February 13, 2024
ADDENDUM NUMBER ONE
Project No. ENG2403768020
For Department of Natural Resources

PROJECT DESCRIPTION: DNR STARVE HOLLOW ADA IMPROVEMENTS

ideaSHIELD® 4" COLLAPSIBLE LOCKING BOLLARD

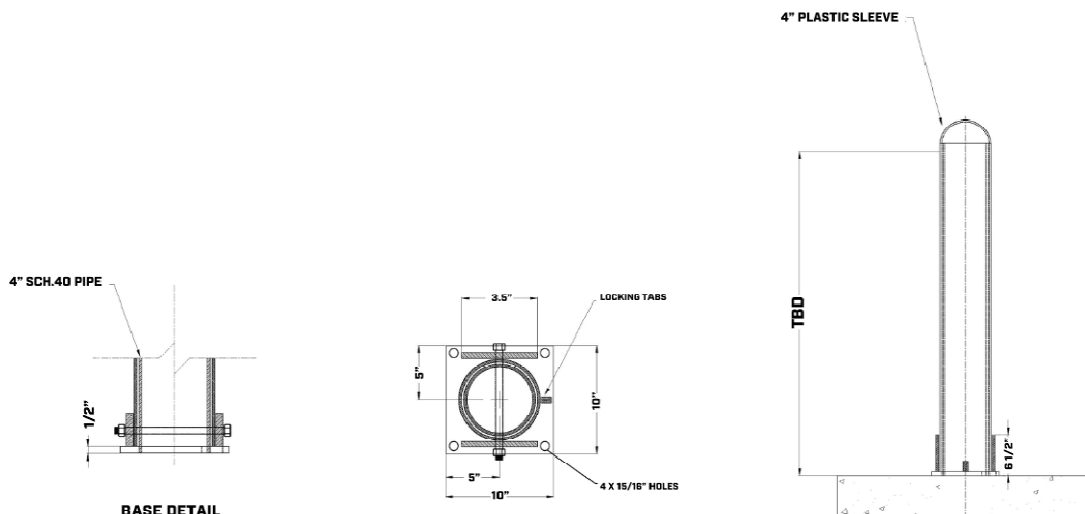
ITEM NO. 3 – All proposed removable bollards (6) six total shall be of the fold down type as shown on the following page and Ideal Shield or equal. Contractor shall coordinate with DNR/Engineer on final placement of bollards at Pre-Construction meeting and plastic bollard sleeve color. Bollards shall be 42" height above grade. All bollards shall be anchored to a 15" diameter concrete base (4,000psi concrete) at a depth of 30". Each bollard shall receive (4) 1/2- inch diameter x 12-inch length concrete "L" anchors (galvanized).

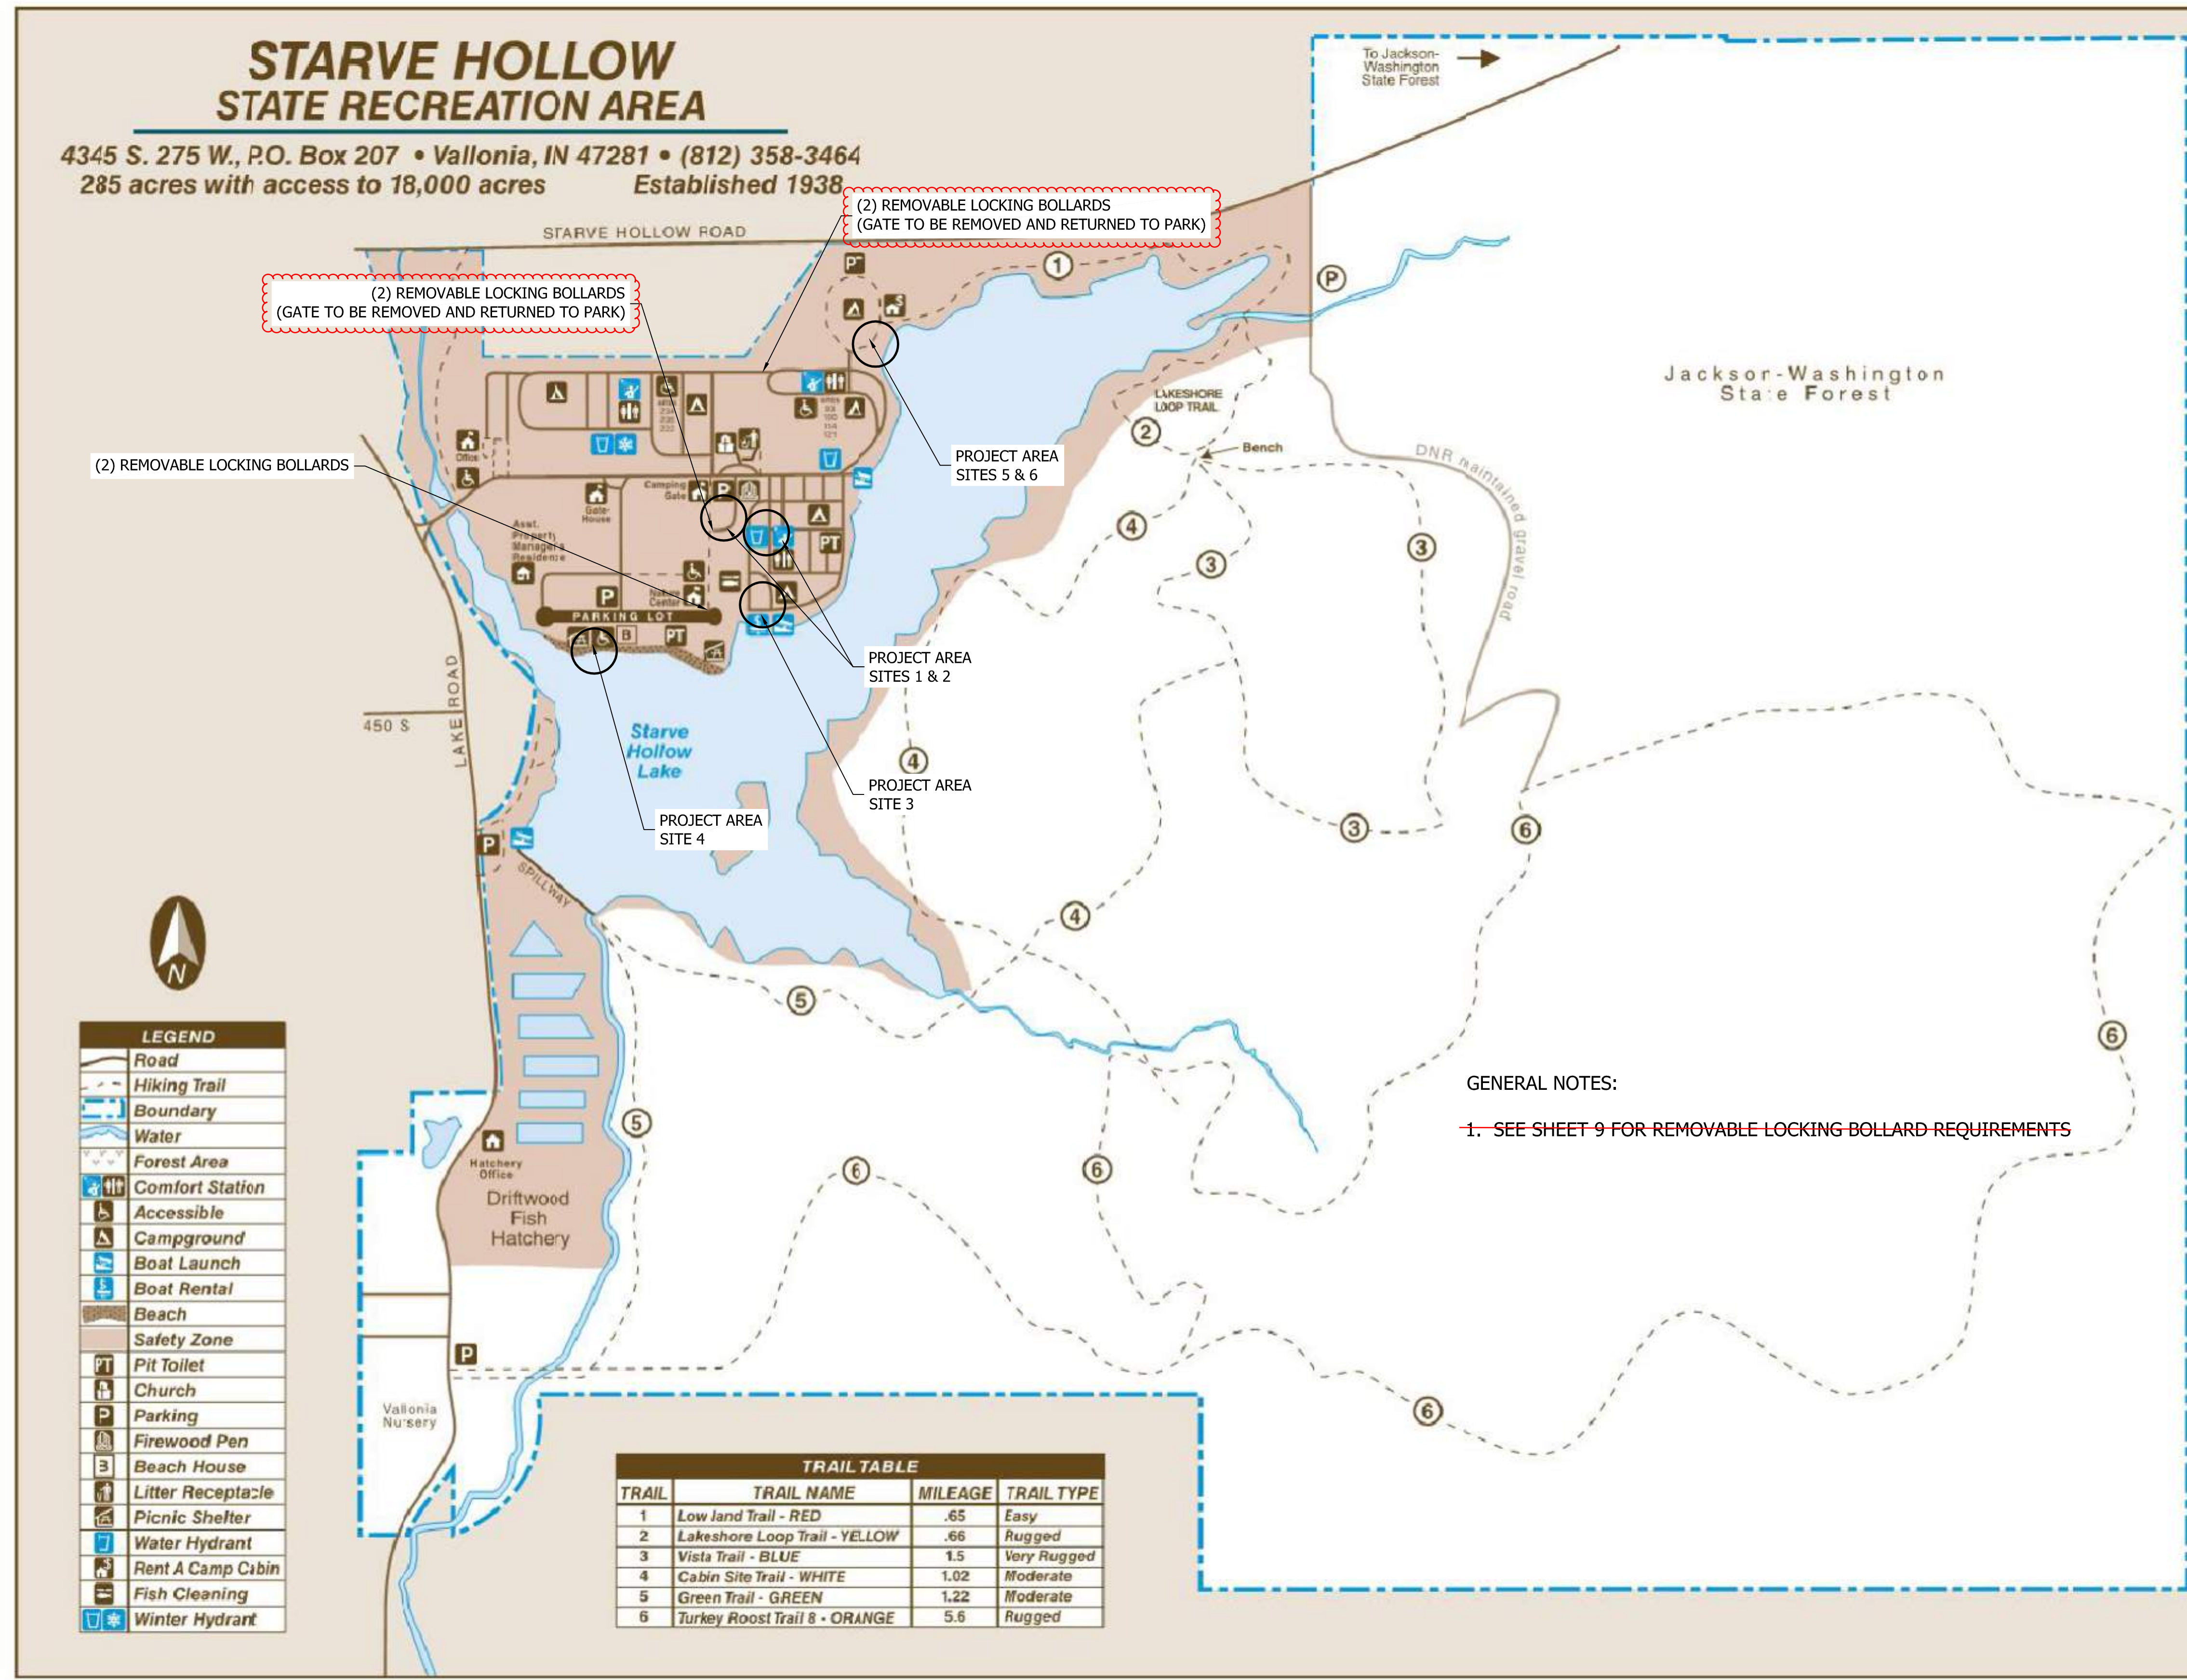
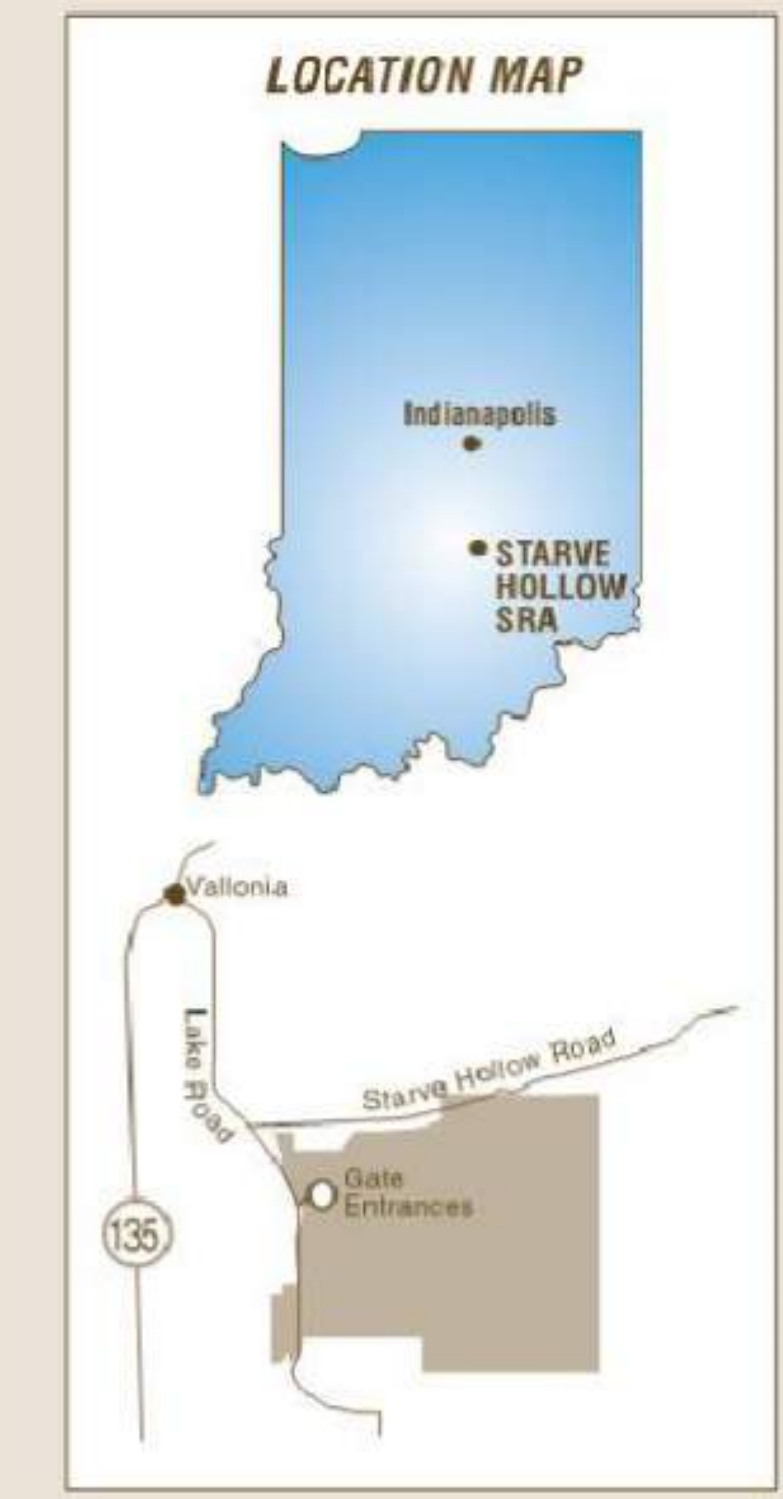
ITEM NO. 4 – At (2) two locations as shown on attached revised overall plan and below, existing gates shall be removed and returned to DNR. Existing gate post shall be left in place and painted to match proposed bollard colors.

- **ITEM NO. 5** – DNR will cut all trees required for the project prior the April 1 Bat habitat date with any remaining debris stacked for removal. The contractor will be responsible for removal or relocation of any remaining cut tree debris. DNR will keep any cut trees on site. Location shall be coordinated with DNR during Pre-Construction meeting.
- **ITEM NO. 6** – Site 5; the striping for the ADA space has been modified as shown on the attached revised plan sheet.
- **ITEM NO. 7** – The proposed pavement on Site 3 shall be made flush with the existing concrete pad at the dock ramp.

FILE NO: 23-12862
 CLIENT NAME: INDIANA DEPARTMENT OF NATURAL RESOURCES
 PROJECT DESCRIPTION: DNR STARVE HOLLOW ADA IMPROVEMENTS
 SHEET TITLE: SITE 1
 DESIGN PHASE: FINAL PLANS
 SHEET NUMBER: 3

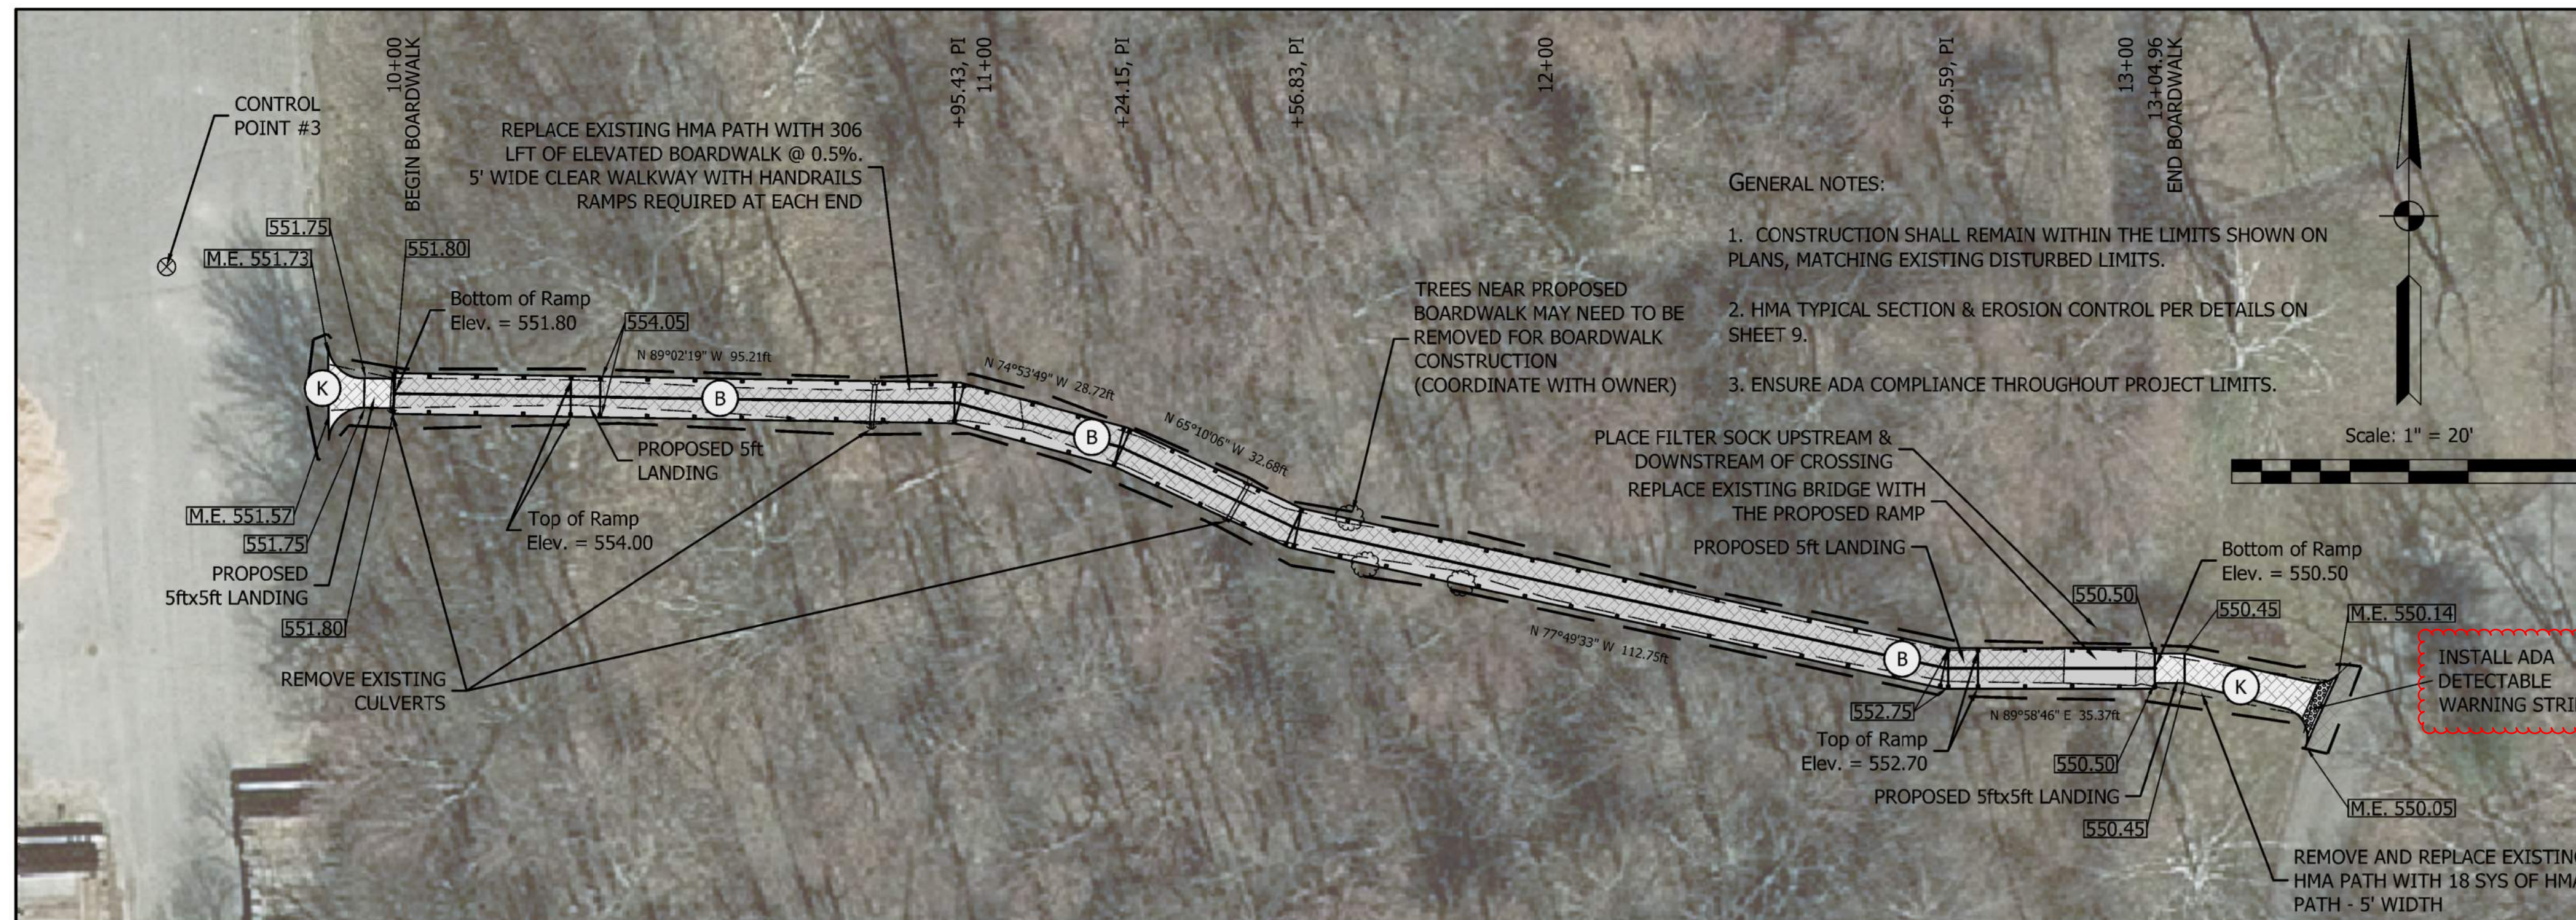
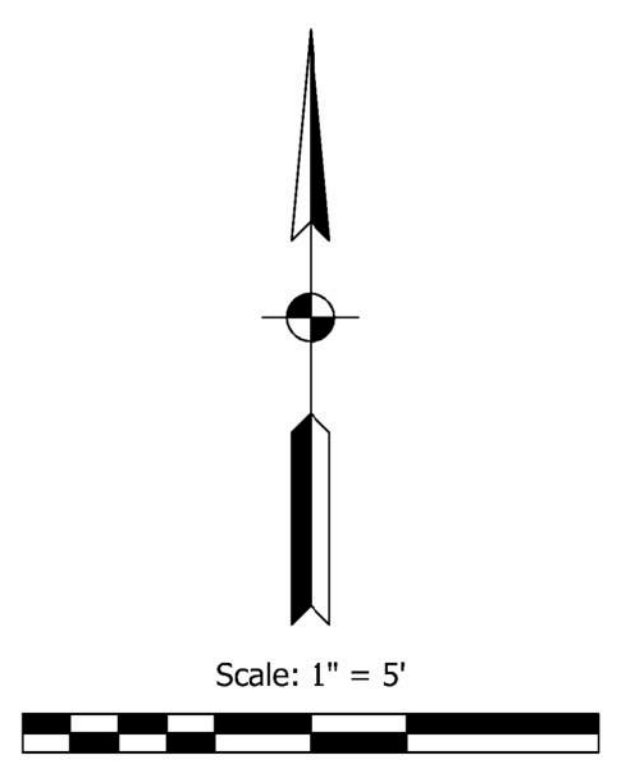
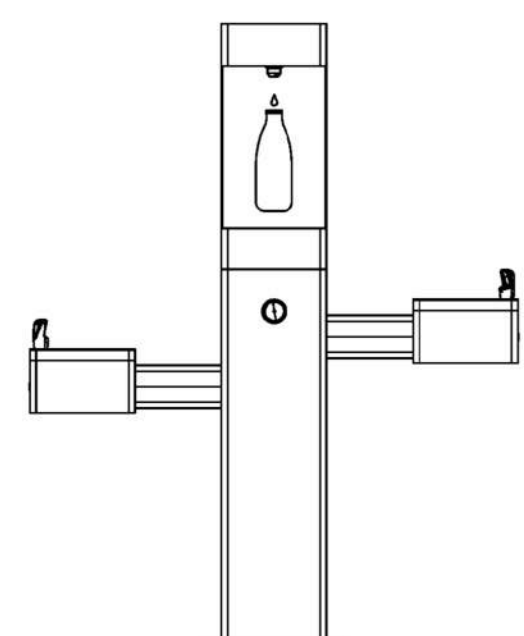
ITEM NO. 1 – Site 1 shall receive (3) detectable warning strips at roadway intersections as indicated on the plan sheet revision attached. Site 2 shall receive (1) detectable warning strip.

ITEM NO. 2 – Site 1 shall receive an ADA compliant drinking fill station with a bottle filling station included. Drinking fill station shall be Global Industrial Outdoor Bottle Filling Station w/ Bi-Level drinking fountain Model # WB761220GN in color (Green) or equal.

ADA OUTDOOR FILLING STATION W/ BI LEVEL FOUNTAIN
 NOT TO SCALE
 Global Industrial Outdoor Bottle Filling Station w/ Bi-Level drinking fountain Model # WB761220GN in color (Green) or equal
